**ADDENDUM NUMBER 01**

**LOTTERY HEADQUARTERS RENOVATIONS**

**DIVISION OF PUBLIC WORKS PROJECT NUMBER 81237R**

**March 22, 2024**

**GENERAL NOTES:**

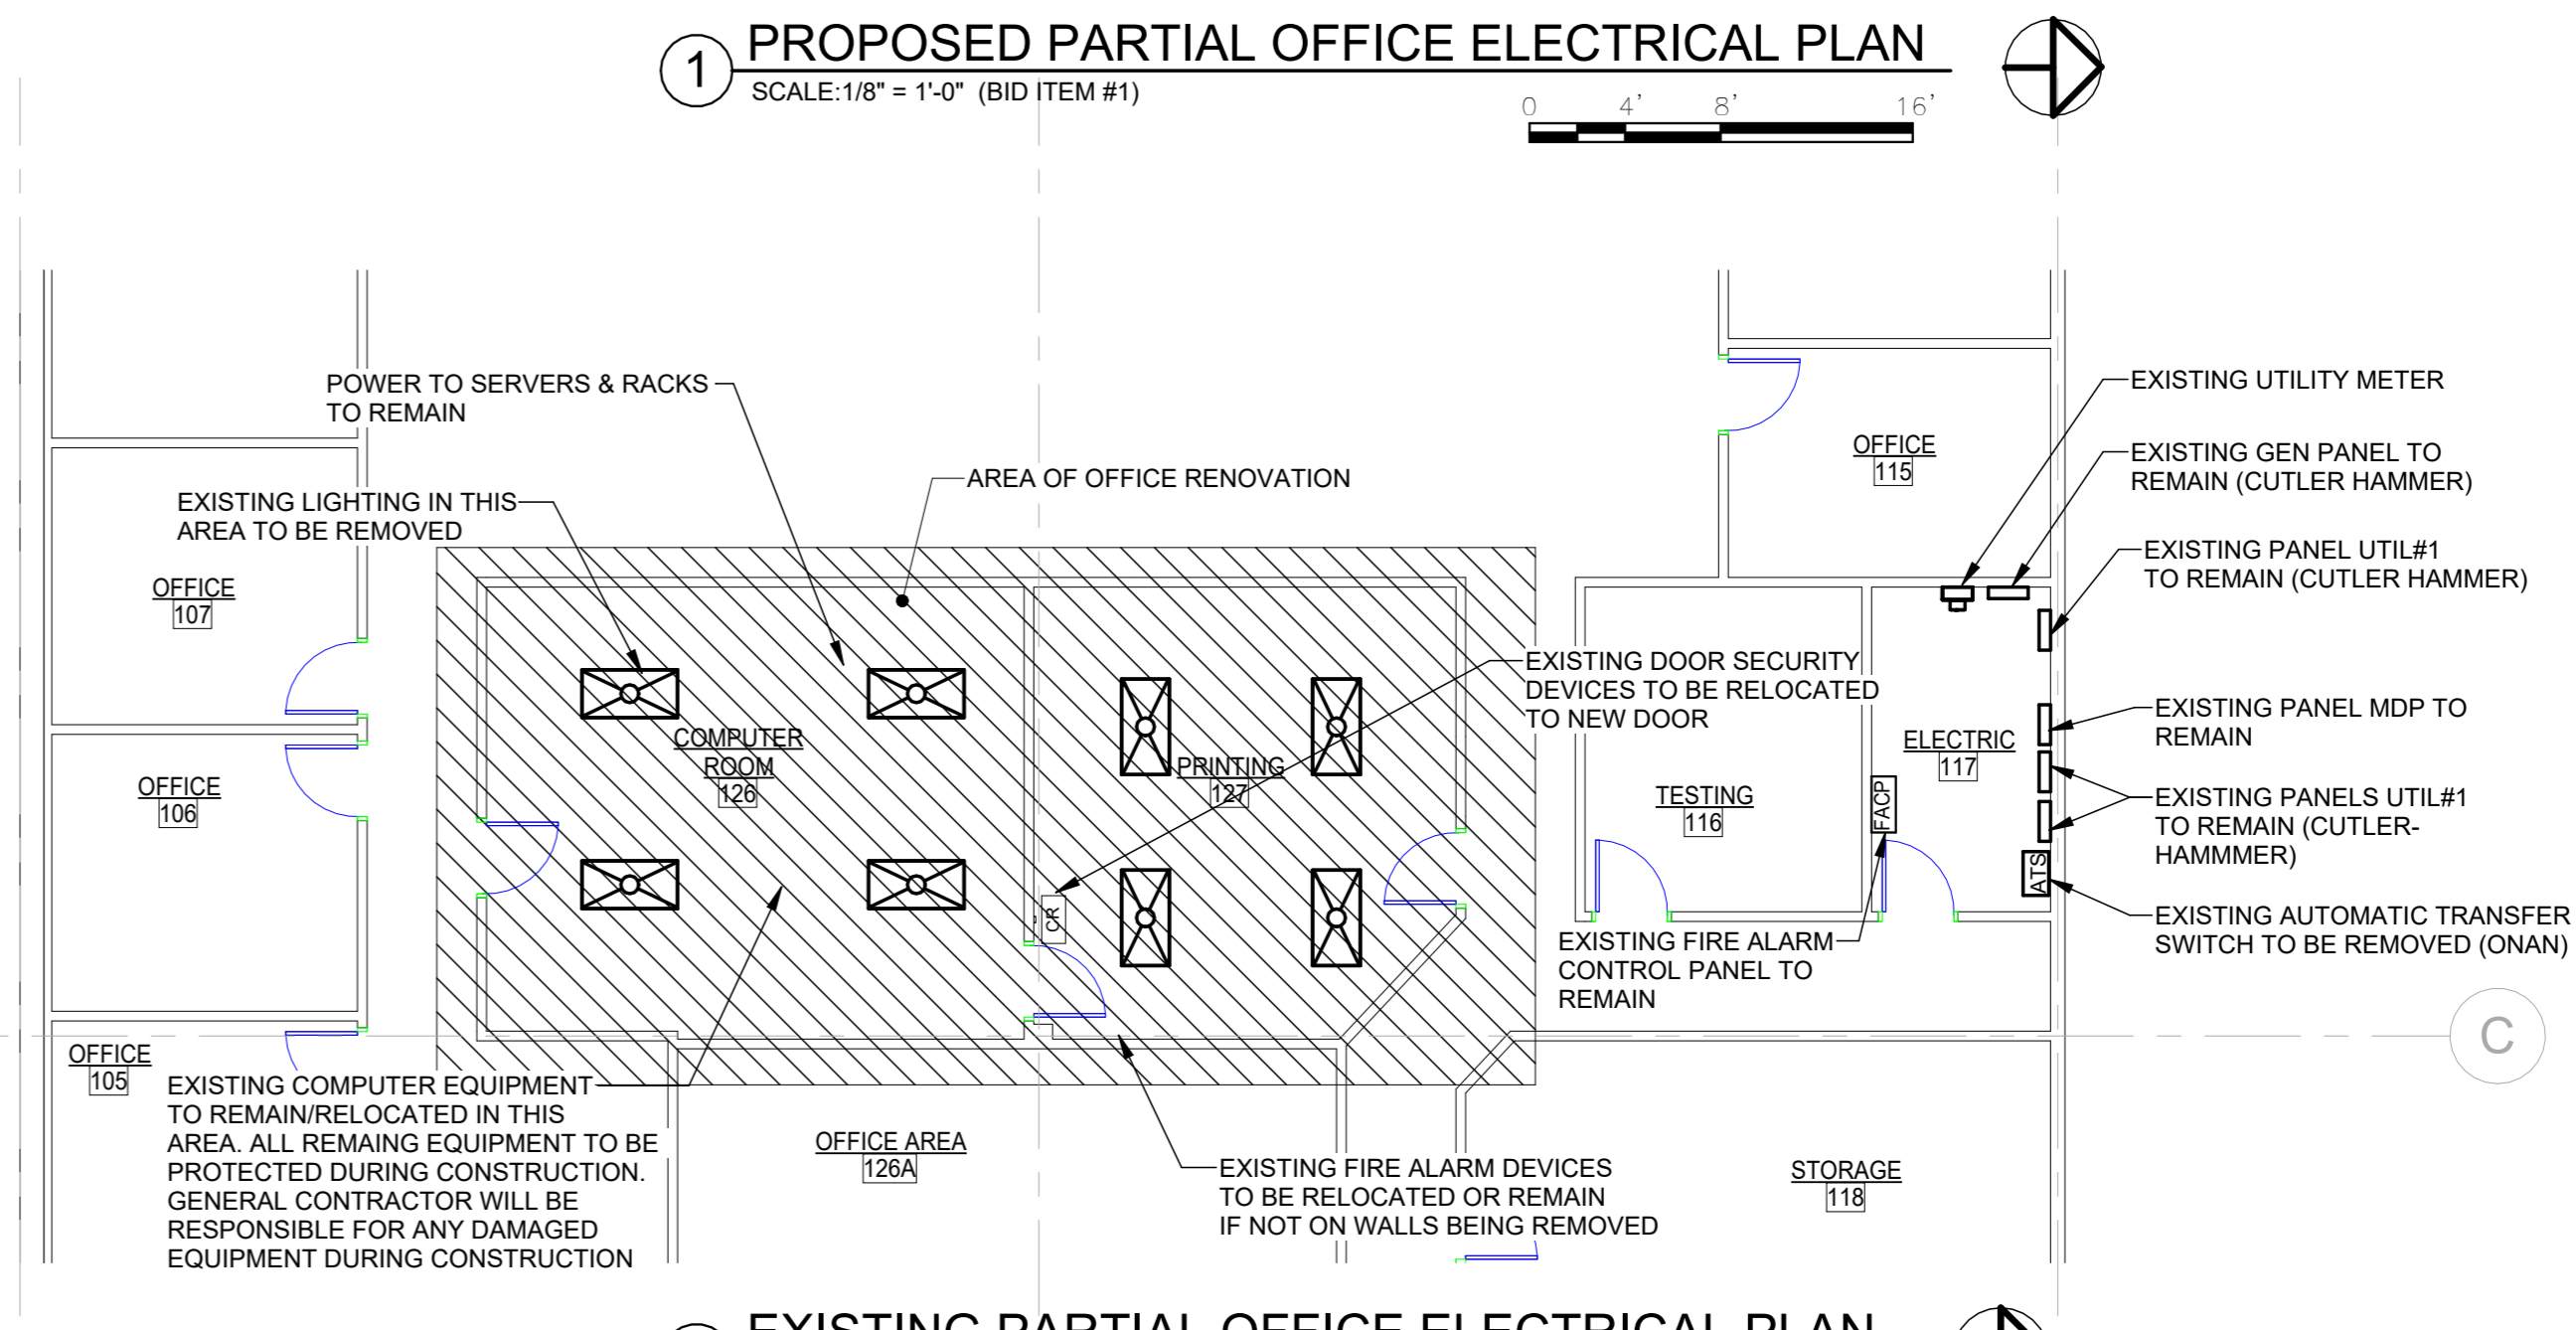
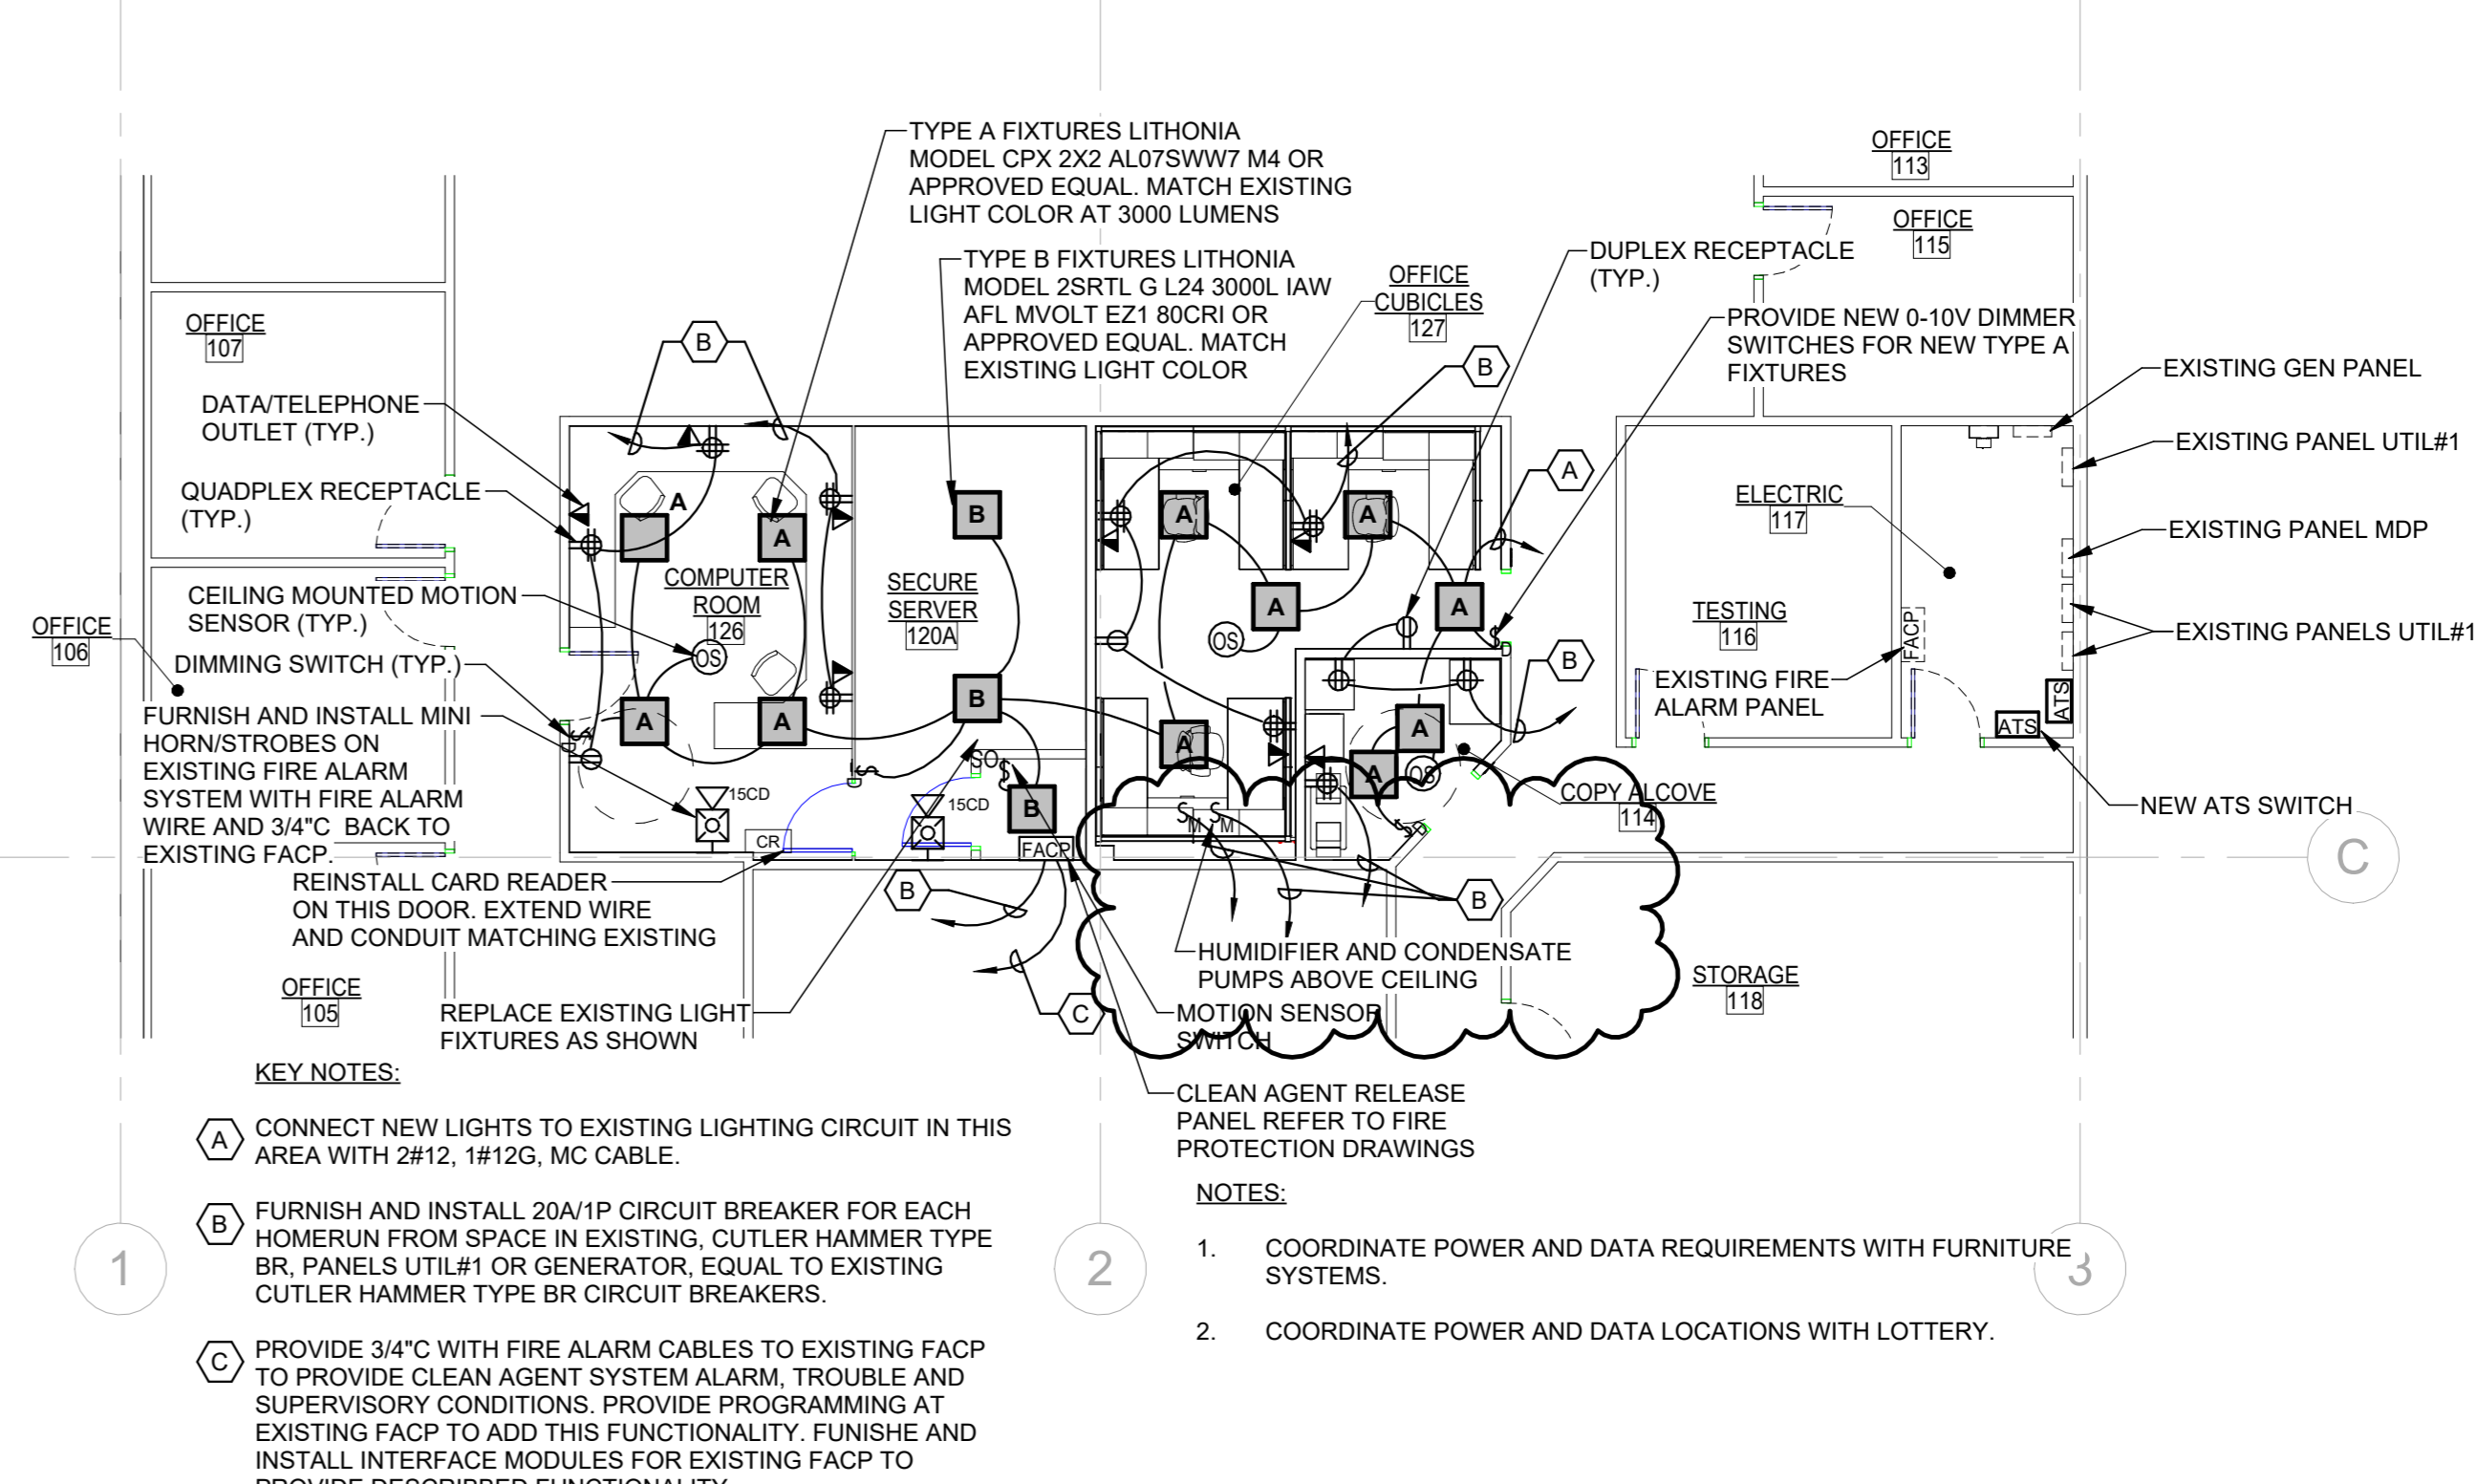
27. Question: Plan E101 shows the existing generator and existing underground exterior conduits being removed and disposed. New generator to be installed at adjacent location with new underground exterior conduits. Please confirm total interior concrete slab on grade square footage that will need to be sawcut – removed – patched in order to connect the new generator exterior conduits to the existing interior conduits.

28. Question: The provided “Information Report” sheet contains a line item #904 with the description “Provide and install new interior conduit for new emergency generator”. Please provide additional information on this scope: How much conduit will be required? What is the total lineal foot distance from the exterior wall to the final connection point, electrical room? Would this work be done during regular hours or off hours? Provide conduit material specification. Please confirm the new conduit will be installed overhead.

**Response:** *The intent is not to disturb the existing interior conduits under the concrete slab. If existing conduits are in usable condition and new wires can be pulled through them, they will be connected to the new generator through underground conduit on the exterior of the building.*

**Response:** *The intent of line item #904 is to provide a unit price to provide a conduit from the new generator to the electrical room should the existing conduit not be usable for the new conductors. The Bidder is responsible for visiting the site and verifying all dimensions, distances and quantities prior to submitting their bid. Provide and install new interior schedule 40 electric galv. conduit from new emergency generator entrance to new transfer switch within the electrical room. Provide (1) 2” dia. and (1) 1” dia. Vertical and horizontal run approx. 90 L.F., secure to structural frame as high as possible not to interfere with existing equipment. The work will be done during normal business hours with the least amount of disruption to the Owner’s use of the building. RGS conduit shall be used where subject to damage and on the exterior.*
